**164 Willow Avenue, Fairfax, CA  
Vegetation Fuels Management Plan  
&  
Tree Protection Plan**

### **Objections to Proposed House at 164 Willow Avenue**

### REPORT ON PROPOSED DEVELOPMENT OF 164 WILLOW AVE., FAIRFAX, CA

**Photographs of Tree #22**

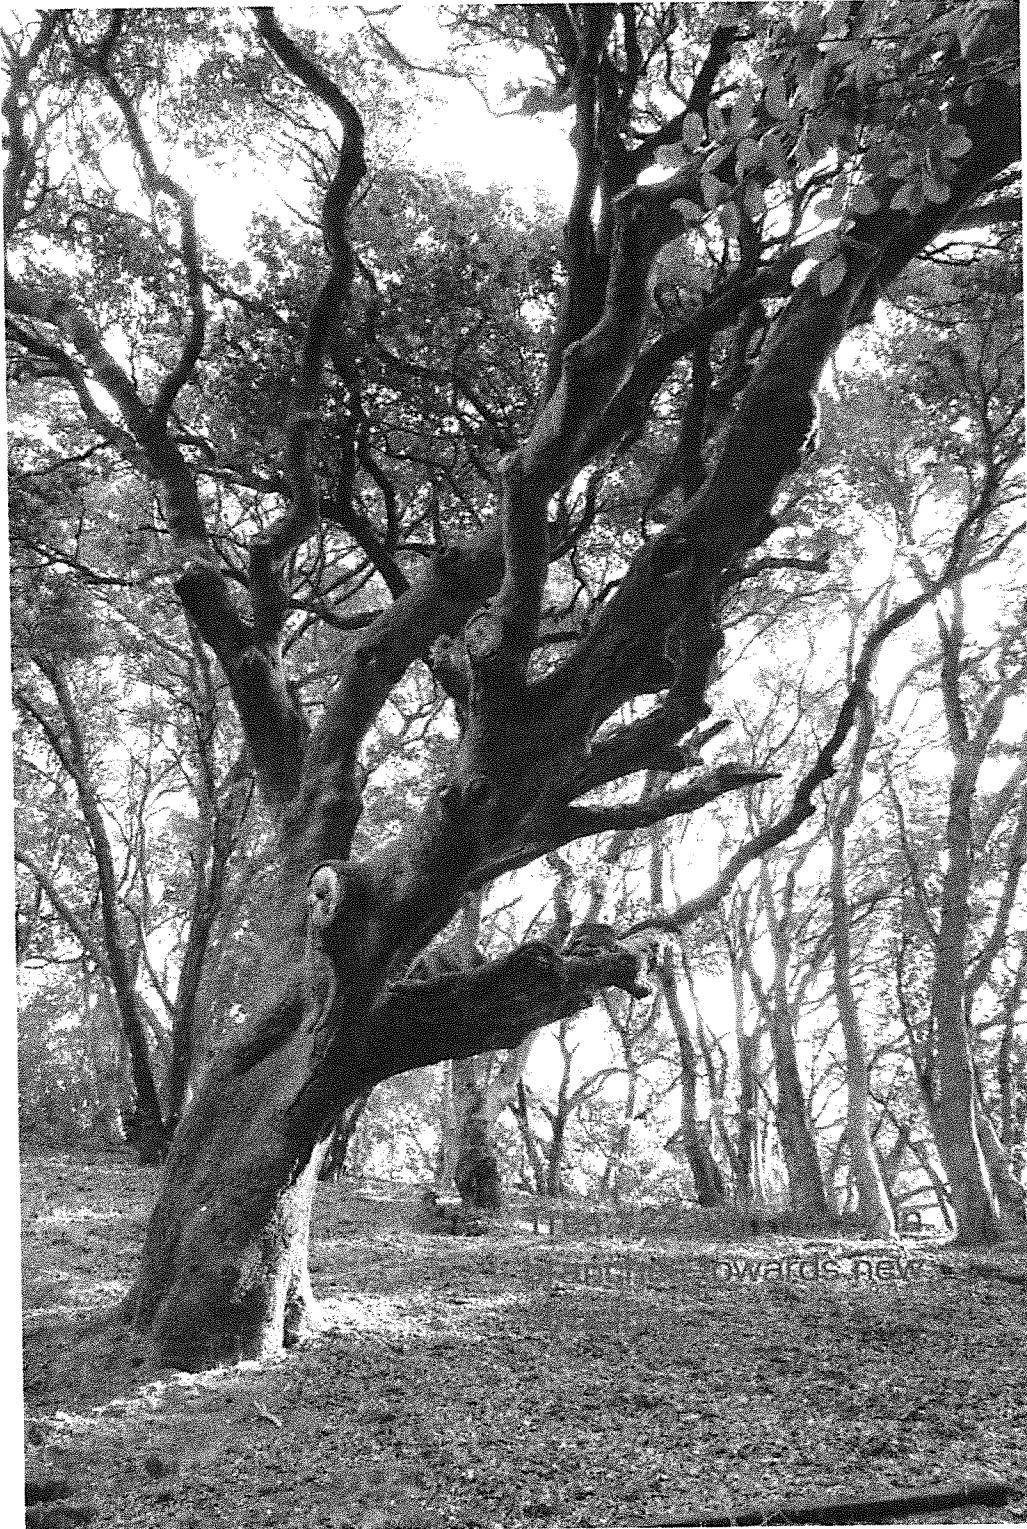
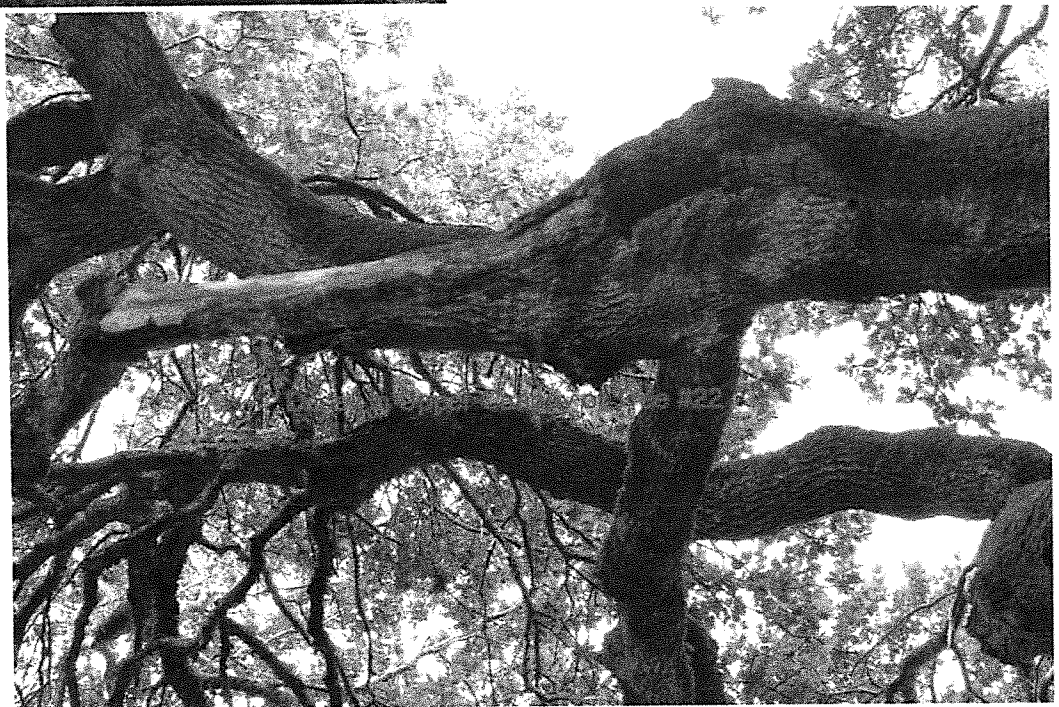
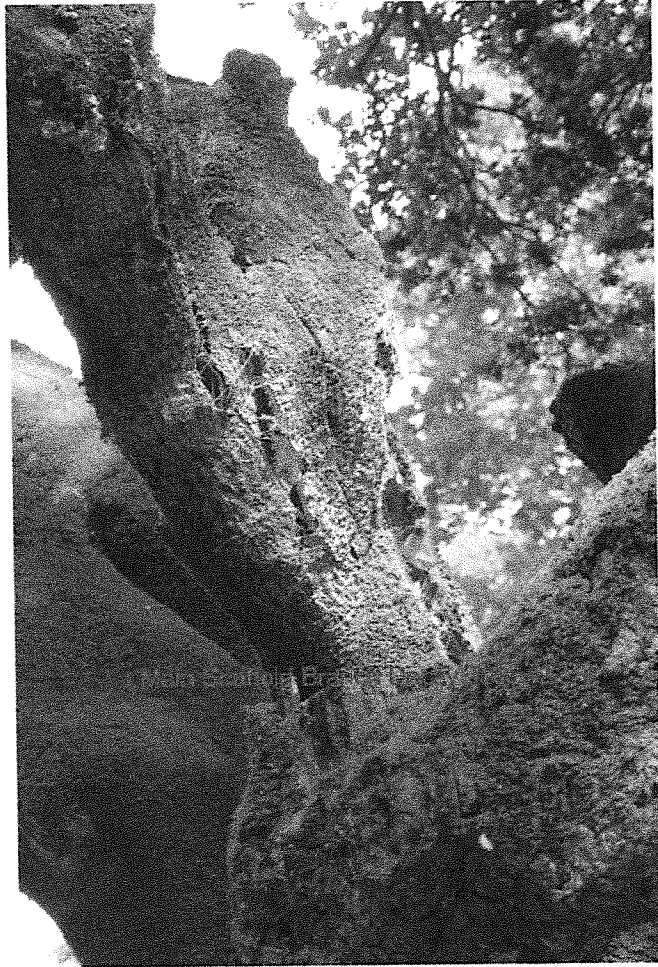
The parcel is described in the arborist's report as grassland, chaparral, and oak/bay/madrone/toyon trees and understory. This description fails to reference the fact that the trees on the property are particularly beautiful. We note that the large coast live oak [identified as Tree #22] provides a majestic canopy that contributes significantly to the visual enjoyment of the area not only by people living immediately adjacent to the property but throughout the neighborhood. Wildlife observed or detected on and around the property include deer, foxes, at least two types of owls, including Great Horned owls, and woodpeckers. A May 2008 assessment of bird species on the nearby 98-acre Wall Property could provide helpful information about some of the additional bird species in the area:

We had some difficulty in reconciling the Staff Report with the Arborist's report in term of the number of oak trees to be removed under the proposal. The Arborist's report lists (of the large trees, 12" or more in diameter) 8 coast live oaks, (*quercus agrifolia*) to be removed, including Tree #22, which contributes significantly to the canopy. The dimensions, which include a 38" diameter oak, a 36" diameter oak, a 30" diameter oak, and an 18" diameter oak, are for the tree's diameter at breast height, so these are pretty big trees and not all of them appear to be accounted for in the Staff Report.
